Project	IEEE 802.16 Broadband Wireless Access Working Group < http://ieee802.org/16 >	
Title	QoS Control Scheme for data forwarding in 802.16j	
Date Submitted	2007-05-10	
Source(s)	<p>Hang Zhang, Peiyong Zhu, Mo-Han Fong, Wen Tong, David Steer, Gamini Senarath, Derek Yu, Mark Naden, G.Q. Wang</p> <p>Nortel 3500 Carling Avenue Ottawa, Ontario K2H 8E9</p> <p>Ranga Reddy US Army - CERDEC, USA</p> <p>D. J. Shyy MITRE, USA</p> <p>Arnaud Tonnerre</p> <p>THALES COMMUNICATIONS, FRANCE</p> <p>Djamal-Eddine Meddour</p> <p>FRANCE TELECOM, FRANCE</p> <p>Jeffrey Z. Tao, Koon Hoo Teo, Jinyun Zhang</p> <p>Mitsubishi Electric Research Lab 201 Broadway Cambridge, MA 02139 USA</p> <p>Toshiyuki Kuze</p> <p>Mitsubishi Electric Corp 5-1-1 Ofuna Kamakura, Kanagawa 2478501, Japan</p> <p>Aik Chindapol Jimmy Chui Hui Zeng Siemens Corporate Research Princeton, NJ, 08540, USA</p> <p>Teck Hu Siemens Networks Boca Raton, FL 33431, USA</p> <p>Yuan-Ying Hsu Telcordia Applied Research Center Taiwan Co., Taipei, Taiwan</p> <p>Tzu-Ming Lin, Fang-Ching Ren, Chie Ming Chou, I-Kang Fu ITRI/ NCTU Taiwan 195, Sec. 4, Chung Hsing Rd. Chutung, Hsinchu, Taiwan 310, R.O.C.</p> <p>Torsten Fahldieck Alcatel-Lucent R&I Holdera

Figure 1. Relay MAC header format with proposed 3-bit “priority field”

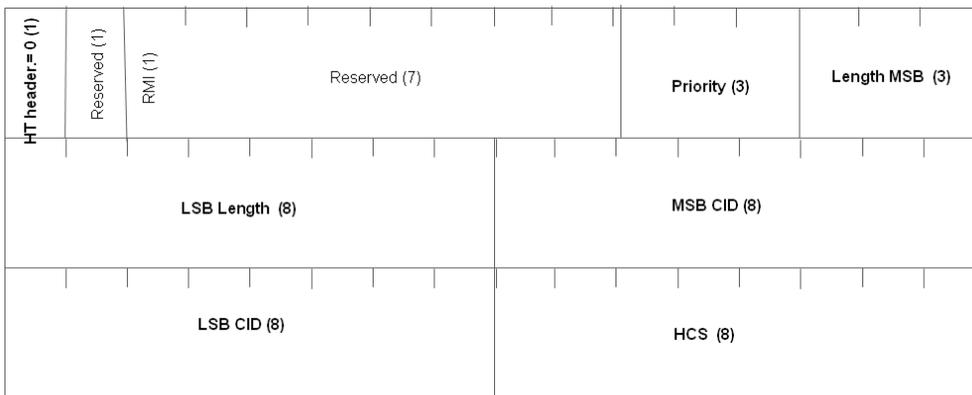
1. Use 3 bits in the “reserved field” of the relay MAC header defined in 07/198r8 as a “priority field” to indicate the priority of the associated MPDU.
2. This 3-bit “priority field” is used for RS to prioritize the data traffic along the relay path between BS and access RS
3. This approach is applicable to distributed scheduling relay system

Figure 1 below provides an example of where the 3-bit “priority field” could be in the relay MAC header specified in 07/198r8.

3-bit “priority field” may be used in the relay MAC header to indicate the priority of the associated MPDU. The location of “priority field” in relay MAC header is to be determined.
